**INDEPENDENT VERIFICATION  
OF  
SAN ONOFRE NUCLEAR  
GENERATING STATION UNITS 2 & 3  
SEISMIC DESIGN  
AND  
QUALITY ASSURANCE  
PROGRAM EFFECTIVENESS**

**VOLUME 2  
PROGRAM RESULTS**

**SCE** *Southern California Edison Company*

**APRIL 5, 1982**

Fig. 7-1. MODSAP model of the safety injection water tank

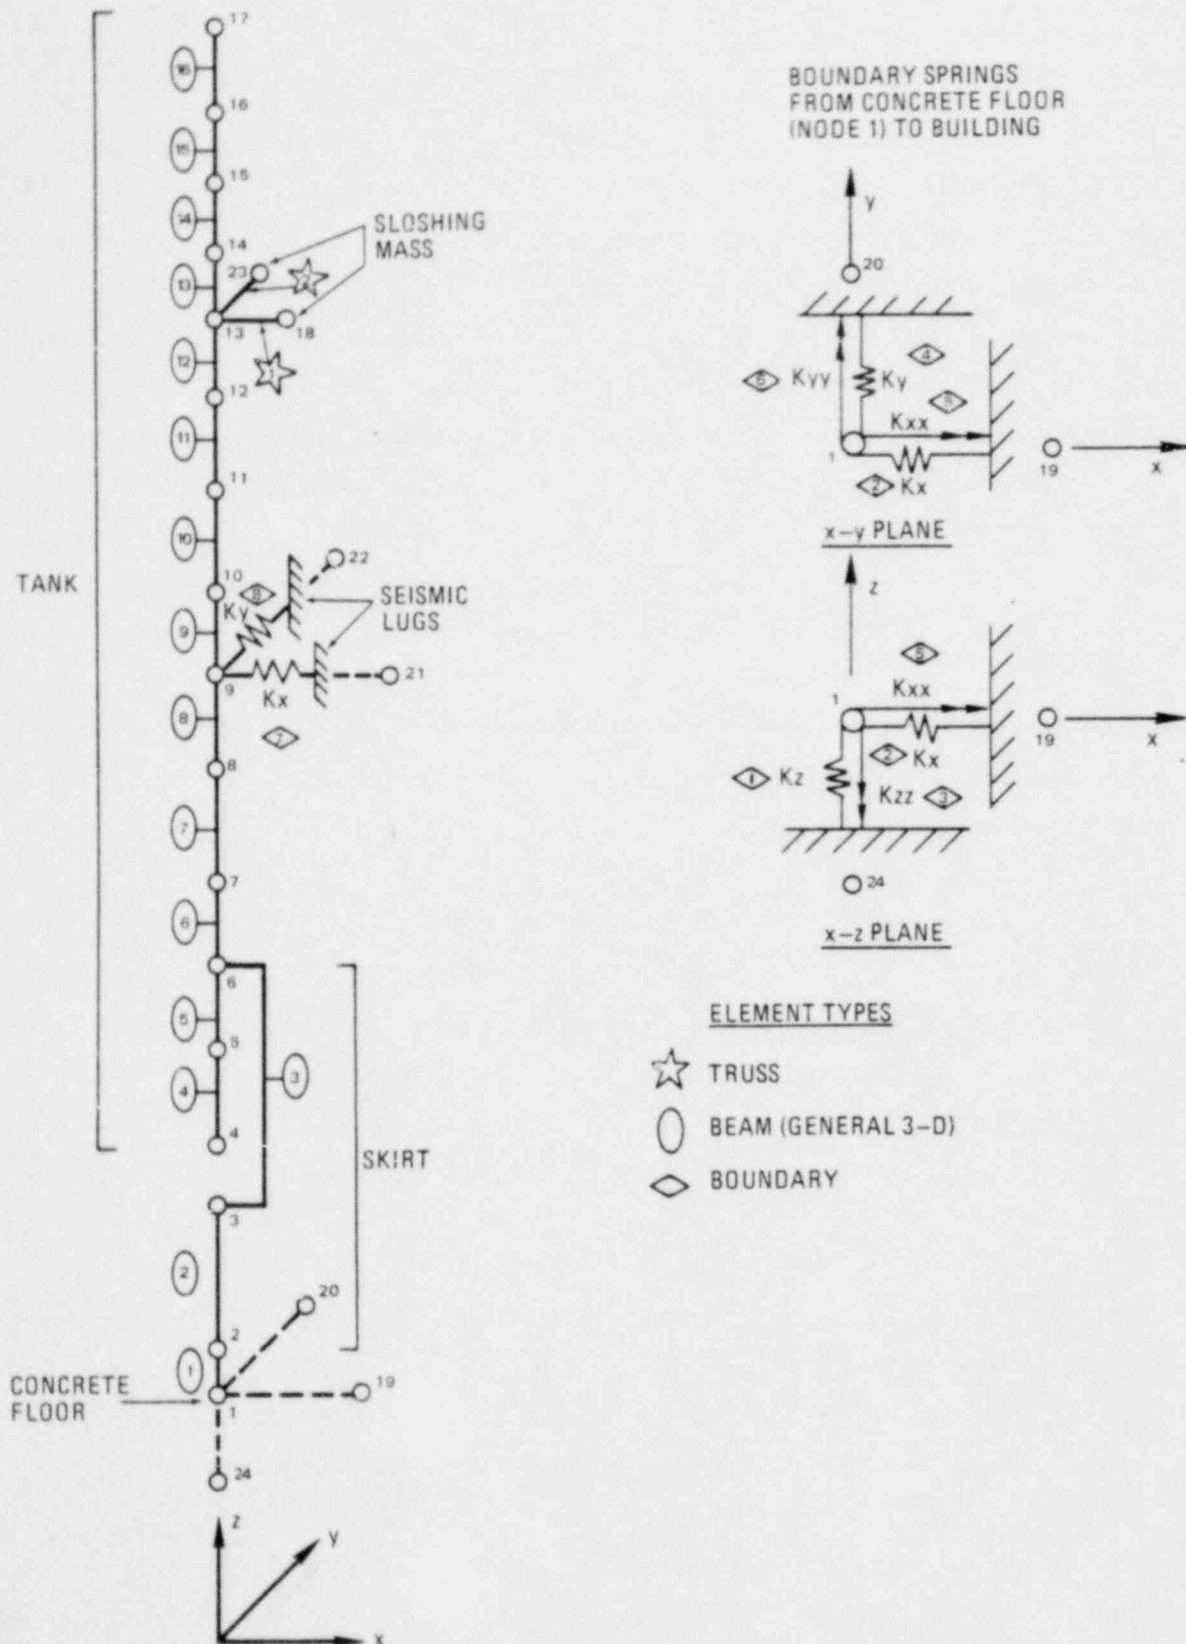
The MODSAP stick model, shown in Fig. 7-1, includes the dynamic effects of the water slosh. This model was used to evaluate the effects of the OBE and DBE response spectra. Hand calculations and the computer results of the MODSAP model were used to estimate the effects of seismic restraint-to-floor displacements. In all cases these results were consistent with the results of the CE analysis.

1. The mass moment of inertia used by CE for the concrete floor was too small. This was the subject of PFR 0037 resulting from the design review of this task under Features 3, Section 4.5.5.
2. The mass properties of CE's concrete floor were input at node 2 instead of node 1.

The results of the independent calculations using different analytical techniques performed by TPT confirmed the seismic design adequacy of the LPSI pump support mount designed by BPC and the safety injection tank designed by CE/Ingersoll Rand.
